PARK CITY MUNICIPAL CORPORATION
ADMINISTRATIVE PUBLIC MEETING MINUTES
PLANNING DEPARTMENT
<https://us02web.zoom.us/j/88167820277>
February 20, 2025

615 Woodside Avenue – Historic District Design Review – PL-23-05838 –
Proposing to Lift a Significant Historic Structure to Construct a Basement Addition and Structural Upgrades in the Historic Residential-1 Zoning District.

1941 tax photo from the HSI form.

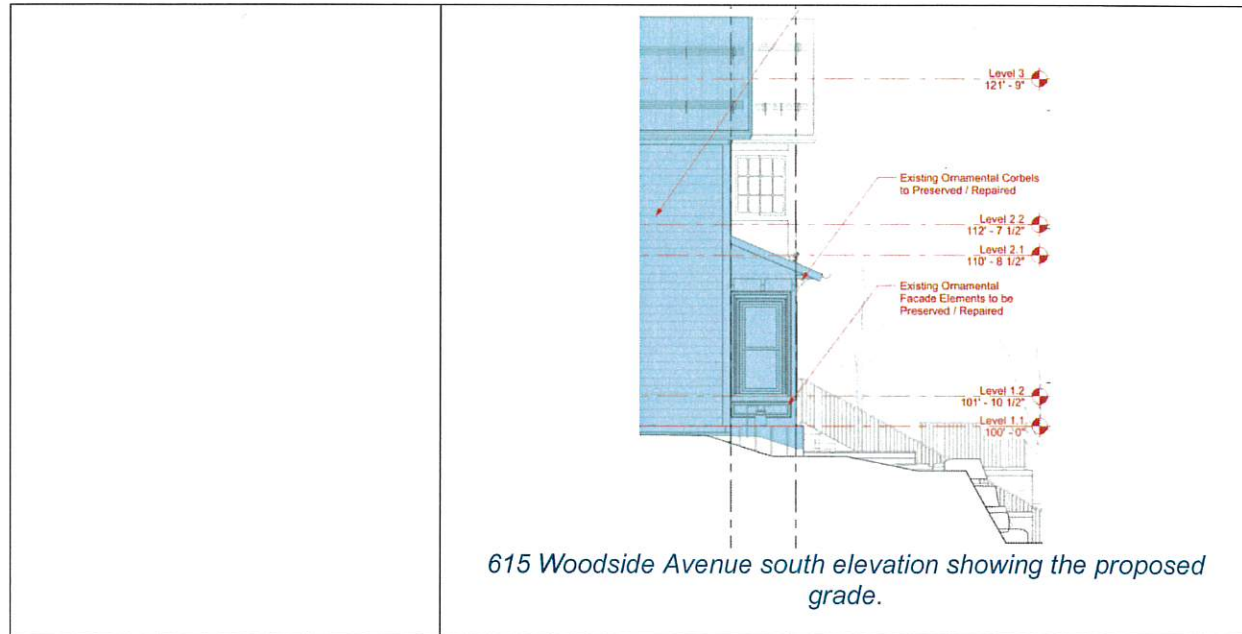
See Condition of Approval 16: The site has been impacted partially on the northeast side due to the 2011 approval of the unenclosed parking area. The Applicant proposes to further modify the southeastern portion site for landscaping. The 1941 tax photo shows the site with a retaining wall at the front, and grade sloping from the structure to that wall.

Staff recommends an updated landscape plan that shows the grade at a more natural slope, rather than introducing retaining boulders at the front of the Historic Structure, and terracing the retaining walls to comply with height limitations within the front setback.

16. The Applicant shall provide an updated landscape plan that reduces the height of new walls in the Front Setback that complies with the Municipal Code of Park City (MCPC) Chapter 11-21 *Utah Wildland-Urban Interface Code*, MCPC § 14-15-1, LMC § 15-5-5(N), § 15-13-2(B)(1)(b), § 15-13-2(B)(1)(c), § 15-13-2(B)(1)(d). The proposed retaining walls may not increase the dimensions beyond the 2011 HDDR approval for the unenclosed parking area. The Applicant shall also update the plans to show the driveway at 10 feet in width maximum. The outdoor barbeque area and proposed glazing for the elevator shaft require modifications for compliance with code prior to building permit submittal.

1941 tax photo from the HSI form.

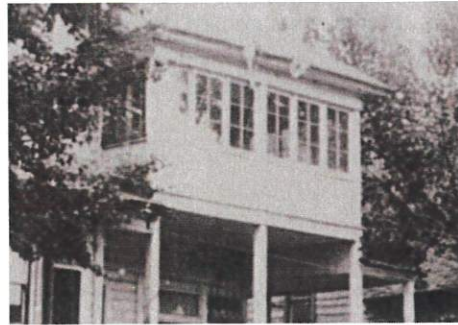
See Conditions of Approval 9 and 11:

The Applicant proposes to restore the front windows over the porch to the 1941 tax photo.

11. Replacement windows on the Historic Structure shall be made of wood. Vinyl and aluminum windows are prohibited.
12. All gutters shall not remove historic material and shall drain away from the Historic Structure.

Front elevation proposed windows, plans provided by the Applicant.

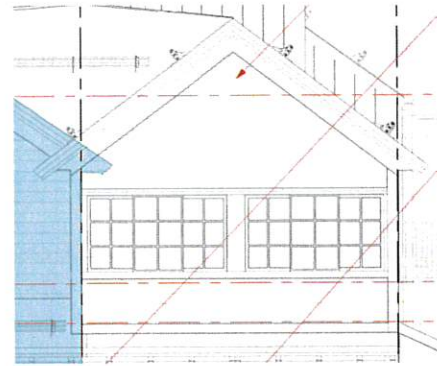
Pursuant to the Applicant's Existing Conditions Report and Historic Preservation Plan (see Exhibit D), none of the windows are original to the structure, therefore the Applicant proposes to replace the windows in the same style and configuration as is existing. The replacement windows shall be wood.

Proposed elevator windows on the north and south sides.

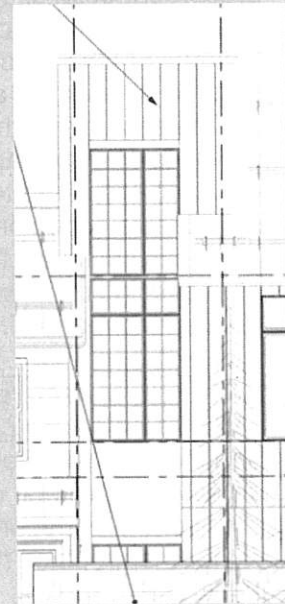
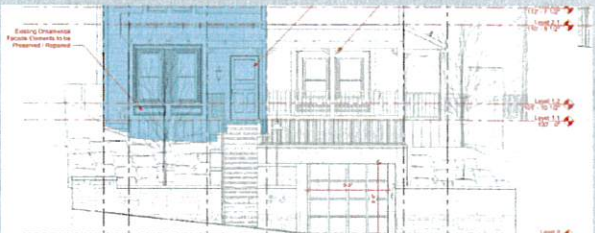
The Applicant proposes windows on the elevator that do not match the 2:1 ratio typically found on Historic Structures. The Applicant will be required to update the plans to reduce glazing to comply with window dimensions and glazing patterns.
